Old Business

SP-24-06 – deliberate on SEQR

<i>SP-24-06</i>	<i>Staff Report – April 15, 2024</i>
<i>Application Type:</i>	Special Use Permit
<i>Project Address:</i>	1133-37 Salina St. S & Raynor Ave. E (Tax Map ID: 094.-19-11.0)
<i>Summary of Proposed Action:</i>	The applicant proposes to remove the on-site automobile repair use and expand the existing on-site convenience store into the space used for the automobile repair. The applicant also proposes to establish 6 on-site vehicle parking spaces (including 1 ADA parking space).
<i>Owner/Applicant</i>	Mark E Mondo (Owner) James Owen, JM Owen Design, LLC (Applicant)
<i>Existing Zone District:</i>	Mixed-Use Transition, MX-3 Zone District
<i>Surrounding Zone Districts:</i>	The neighboring properties to the north, east and west are the Mixed-Use Transition, MX-3 Zone District, and to the south is within the Neighborhood Center, MX-2 Zone District.
<i>Companion Application(s)</i>	MiSPR-24-14: interior and exterior build-out for an on-site convenience store.

Z-2865	Staff Report – April 15, 2024
Application Type:	Zoning Map Amendment
Project Address:	321-23 Cortland Avenue (085.-03-25.0) 323 Cortland Avenue Rear (085.-03-26.0)
Summary o

1 SITE PLAN
 AO.2 1" = 20'-0"

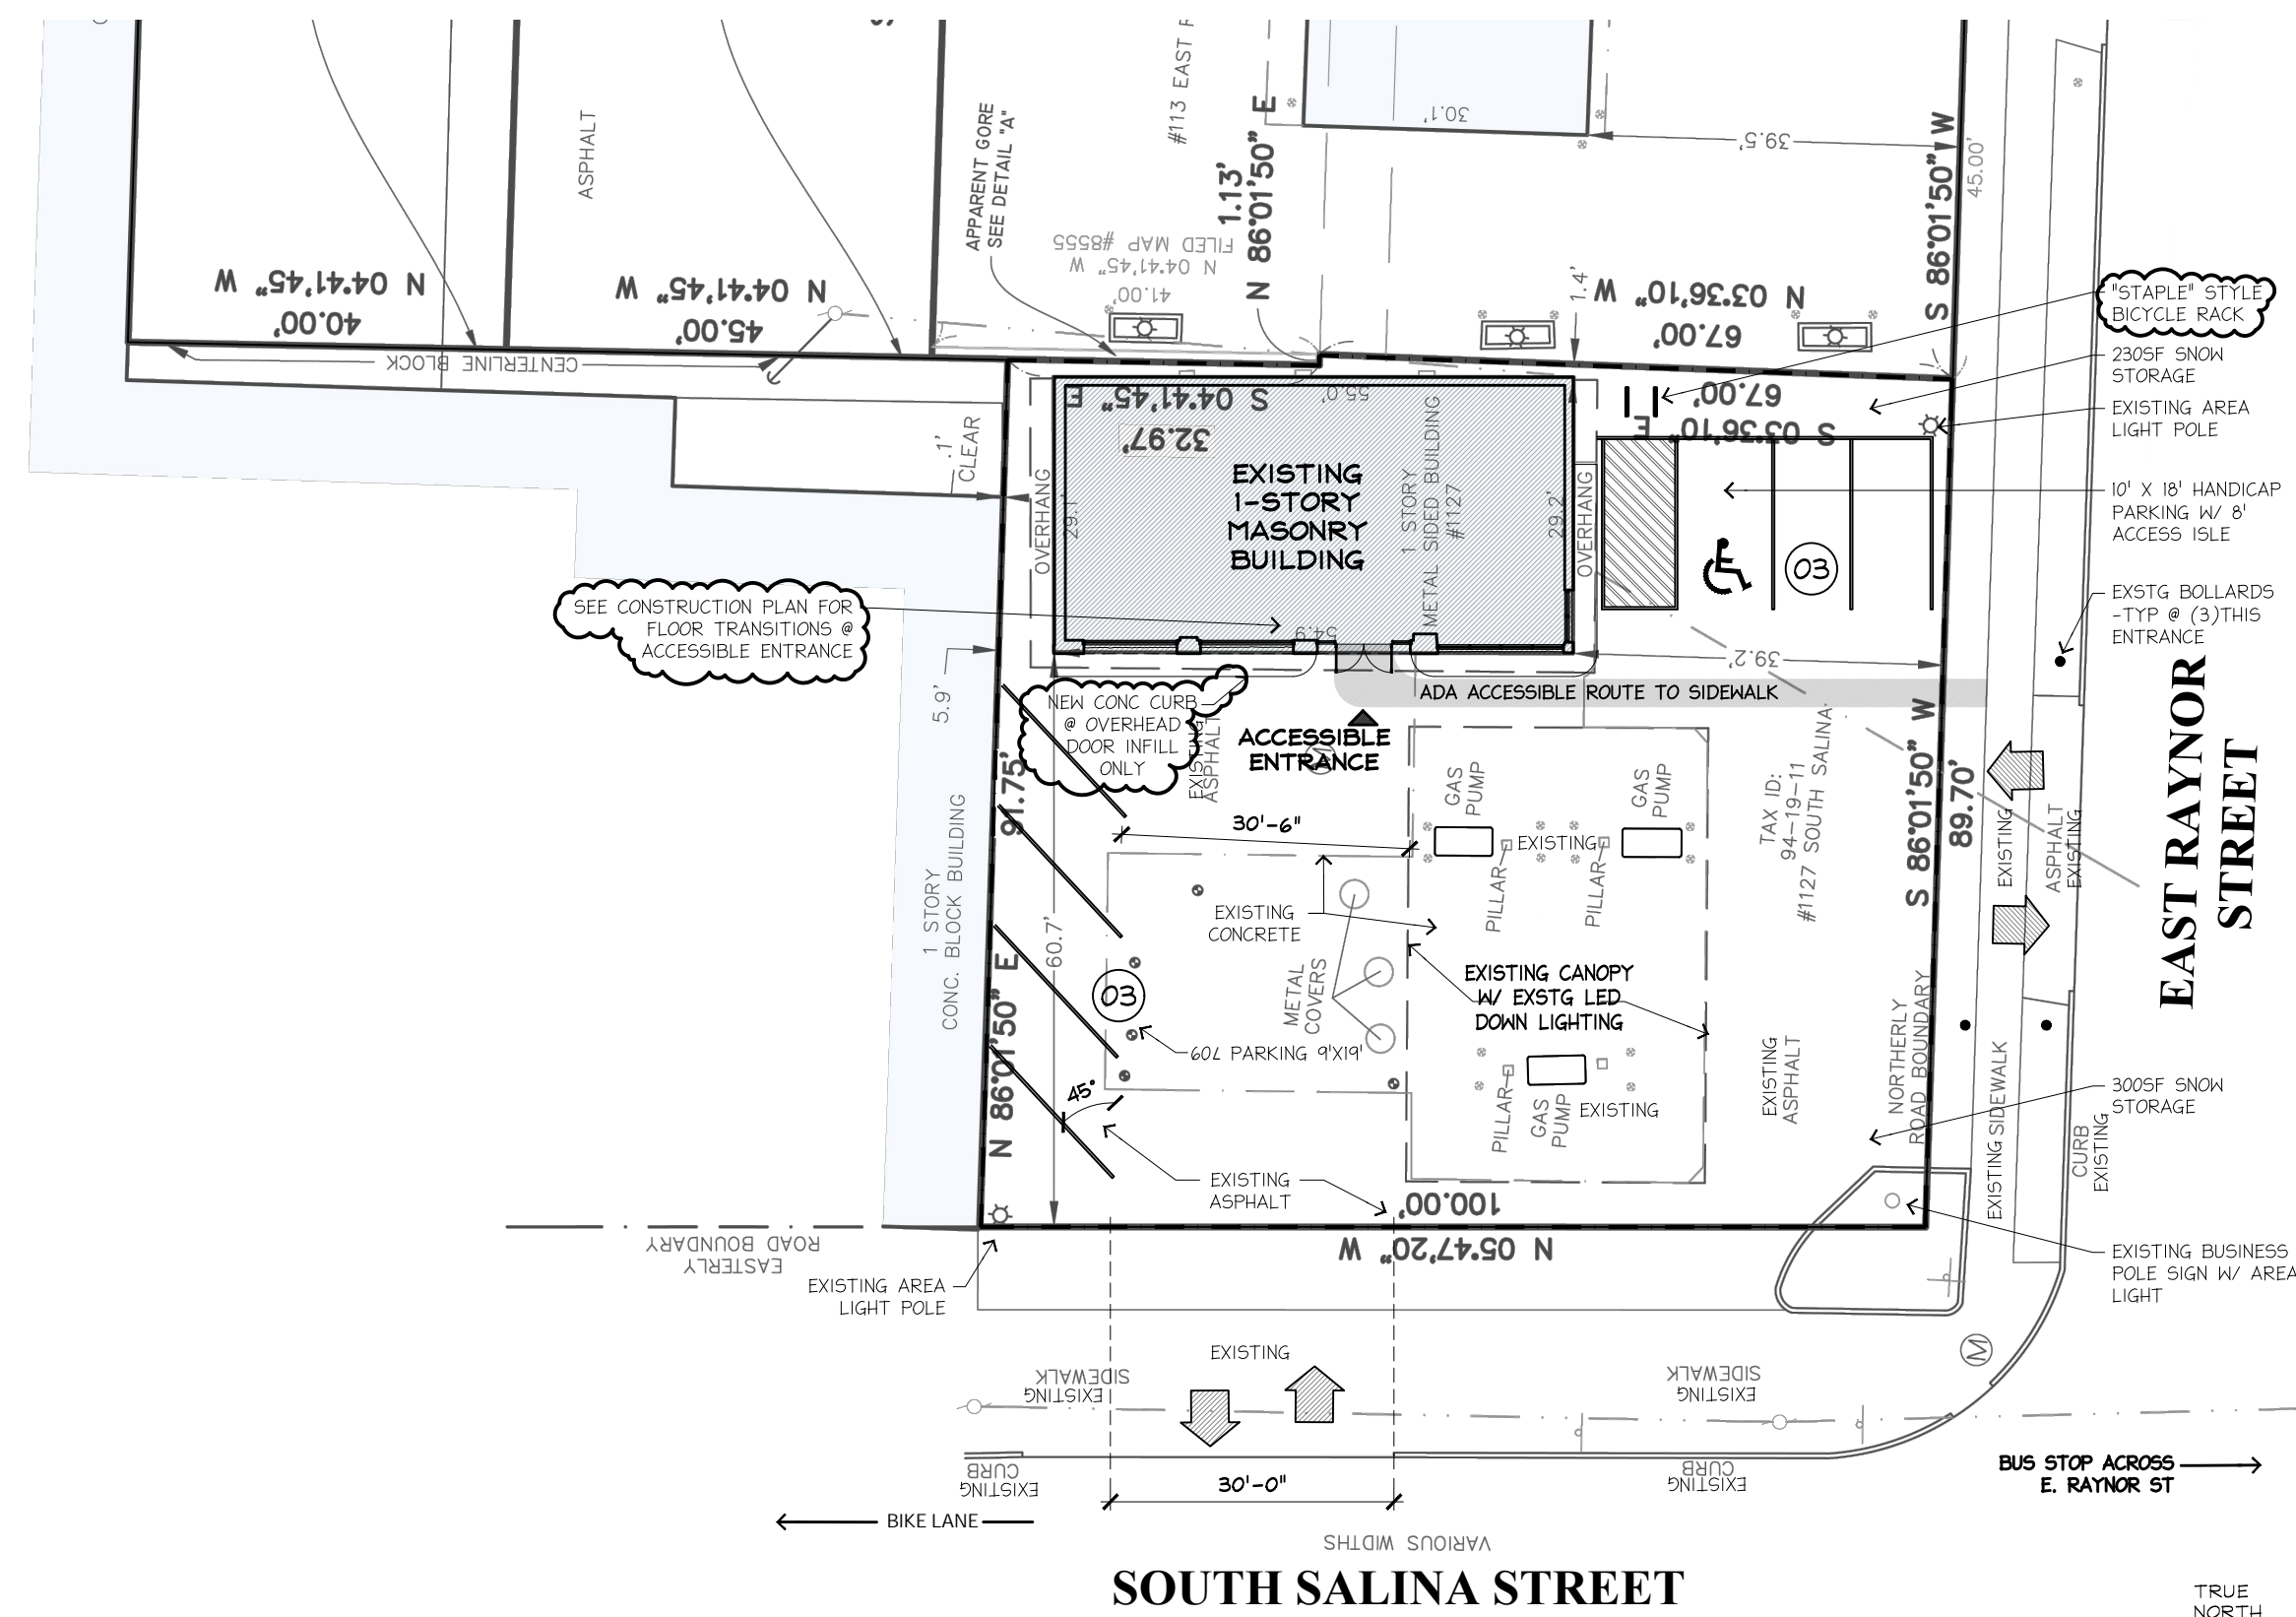
DPW - Transportation Planner	Internal Review Complete	03/26/2024	Neil Milcarek-Burke	Revised plans required: - ADA compliant walkway to/from the main entrance to the Raynor street public sidewalk required - Bike parking required utilizing a staple-style rack (no "wave" racks) in a conspicuous and well-lit area near the main entrance The City has made significant investments along both property frontages in the past several years, including new sidewalks, bollards, porous pavement snow storage areas and new curbing.

Engineering - Design & Construction	Conditionally Approved	03/12/2024	Mirza Malkoc	<ul style="list-style-type: none"> Proposed project is subject to Onondaga County's 1:1 offset. The City requires an offset plan & details for review. Proposed elevations shall be graded to prevent stormwater sheet flow to adjoining properties & to the City R.O.W. Project site shall reduce stormwater sheet flow to the City's ROW or adjoining properties by removing some of the impervious surface area and replacing it with grass/landscape areas. Onondaga County Plumbing Control shall review and approve the plans as well.
Onondaga Co Planning Board	Approved	03/20/2024	Zhitong Wu	<p>Recommendation: No Position with Comment</p> <p>Comment: The Board strongly encourages the City and applicant to work to minimize pavement and to incorporate green infrastructure where possible, in order to minimize stormwater runoff from such an intensely impervious surface.</p>

Water Engineering	Pending	03/11/2024		
Zoning Planner	On Hold	04/09/2024	Zhitong Wu	The proposed locations of parking spaces violates ReZone, Art. 4, Sec. 4.4F(4)c., applicant need to revise the plan or apply for use variance.
Common Council	Pending	03/11/2024		
Planning Commission	Pending	03/11/2024
